Quality Control Check Repot.	Stage: Before Casting Slab (Apartments)	
·

## ATR on Quality Control Check Repot. (Bungalows)

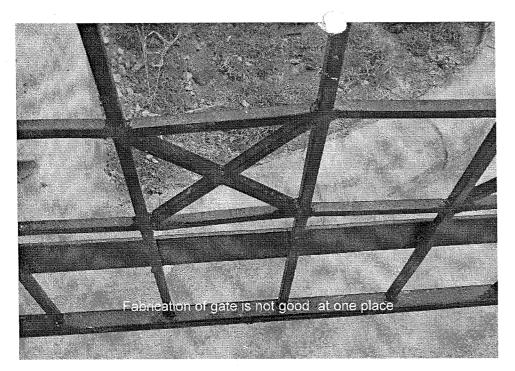
13.	Steel Check - Column steel overlapping length and cranking		Good Avg. Bad
14.	Electrical Conducting	<b>/</b>	Good Avg. Bad
Remarks:	(1) In Beam NO-1 Extra Rod of 30	of 20 not provided.

(2) In Beam NO-8 Extra Bar is sho	of with 6" and in	Same Beam Bottom rods
	are not tied properly.

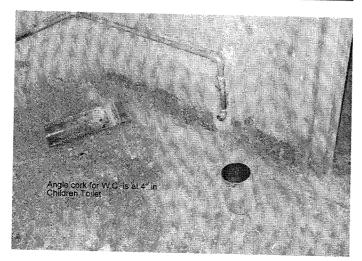
^{4.} In Kirchen, Awaquard point is at 50" (sh. 61 at 56")

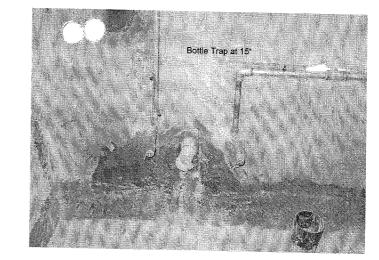
^{5. 20} Master Bed Room, Telephone point /Switch board noraligned property, A.C. plug point is at 66" (657. v. pointisat 2'9".
